Access Compliance Report

Public Rights-of-Way

(Curb Ramps)

Intersection ID: 14349	Main Street: REMOUNT_RD	Cross Street: TOOMEY_AV	Location: SW
ADA ID: EEBEA7EABCC4	Ramp Type: Perp	Initial Pass/Fail: Fail	Overall Compliance: No
Severity Score: 26.25			
Codes/Mitigation Info/Possible Solution		Field Measurements/Component Compliance

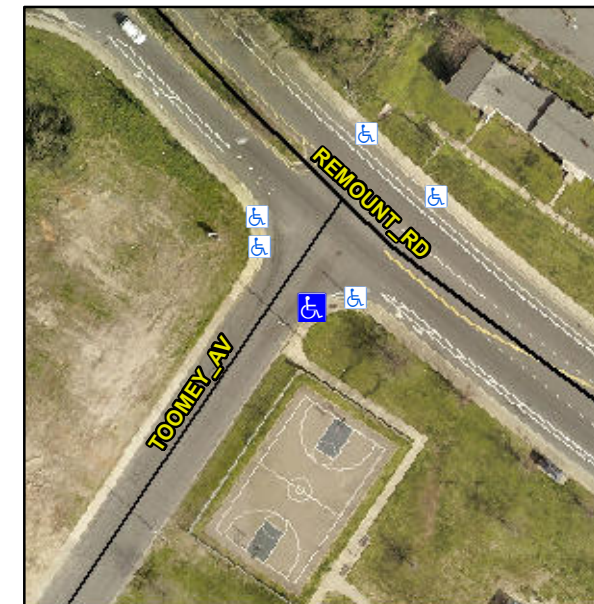
Not Found, R304.2.2, R304.5.3

Compliance	Description	Data	Compliance	Description	Data
N/A	Ramp Length (in)	60.0	No	Ramp Slope (%)	12.1
Yes	Ramp Width (in)	48.0	No	Ramp XSlope (%)	3.4
N/A	Flare Type LT	N/A	N/A	Flare Type RT	N/A
N/A	Flare Slope LT (%)	N/A	N/A	Flare Slope RT (%)	N/A
N/A	Flare Traversable LT?	N/A	N/A	Flare Traversable RT?	N/A
N/A	Landing Length (in)	N/A	N/A	DWS Provided?	N/A
N/A	Landing Width (in)	N/A	N/A	DWS Contrast?	N/A
N/A	Landing Slope (%)	N/A	N/A	DWS Length (in)	N/A
N/A	Landing X Slope (%)	N/A	N/A	DWS Full Width?	N/A
N/A	Landing Curb? (Y/N)	N/A	N/A	DWS Offset (in)	N/A
N/A	Shared Landing?	N/A			
N/A	Gutter Ponding?	N/A	N/A	Gutter Slope (%)	N/A
N/A	Gutter Lip Ht (in)	N/A	N/A	Gutter X Slope (%)	N/A
N/A	Painted X Walk1?	No	N/A	Painted X Walk2?	N/A
	X Walk 1 Direction	To NW		X Walk 2 Direction	N/A
N/A	X Walk 1 Width (in)	N/A	N/A	X Walk 2 Width (in)	N/A
	X Walk 1 Slope (%)	1.0		X Walk 2 Slope (%)	N/A
	X Walk 1 X Slope (%)	2.8		X Walk 2 X Slope (%)	N/A

Remove & Replace Entire Ramp.
